To: T10 Technical Committee
From: Tim Symons, PMC-Sierra (Tim_Symons@pmc-sierra.com)
Date: 4 July 2007
Subject: 07-308r0 SAS-2 Configured zone group.

This is a proposal to add a DEFAULT ZONE GROUP field to the DISCOVER response.

Figure 1 - ZPSDS with a phy configured to zone group 20, assigned to zone group 1

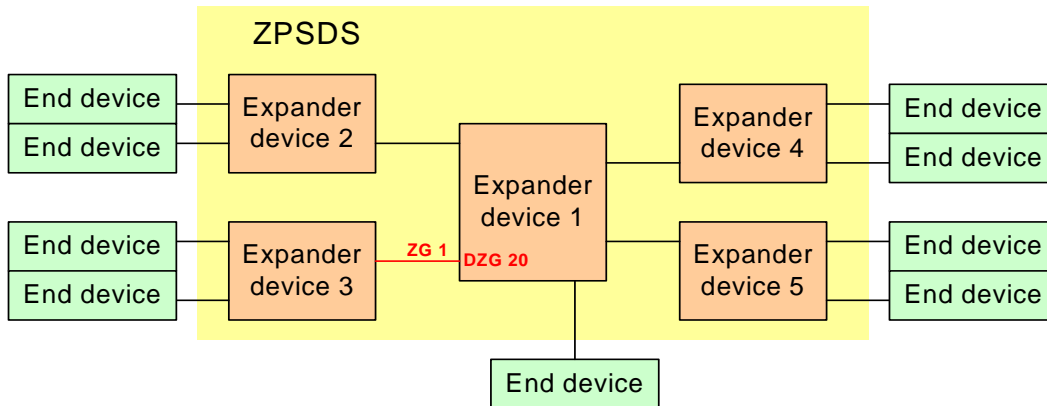
Figure 1 shows a ZPSDS where a phy on Expander device 1, is configured to DEFAULT ZONE GROUP 20, but the zone manager assigns it to zone group 1 because it is attached to another expander phy inside the ZPSDS.

There is no method to identify the default zone group of the phy when the zone manager assigned the phy to group 1. If a zoning expander is removed from the ZPSDS, and the zoning expander phy becomes a boundary phy, then the DEFAULT ZONE GROUP is active.

Figure 2 - ZPSDS with expander device 3 removed.

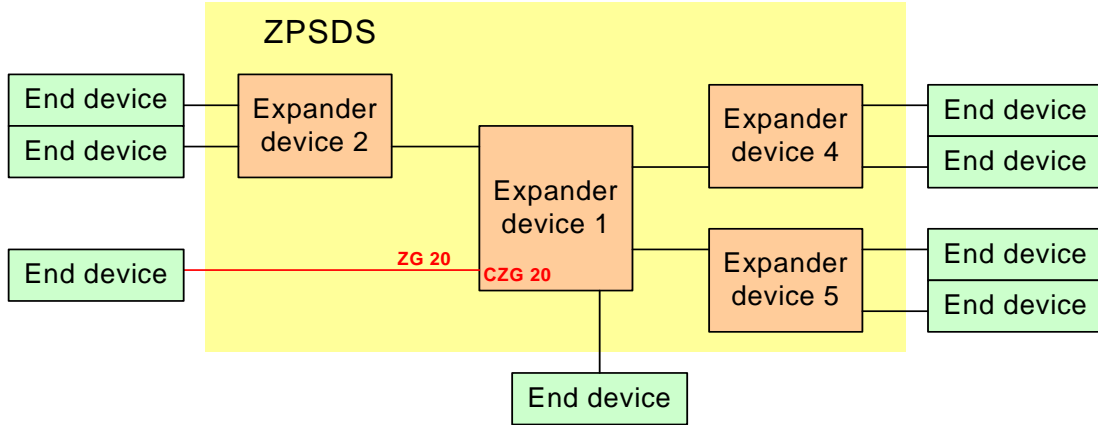
Figure 2 show the ZPSDS with expander device 3 removed, and the configured phy zone group is activated.
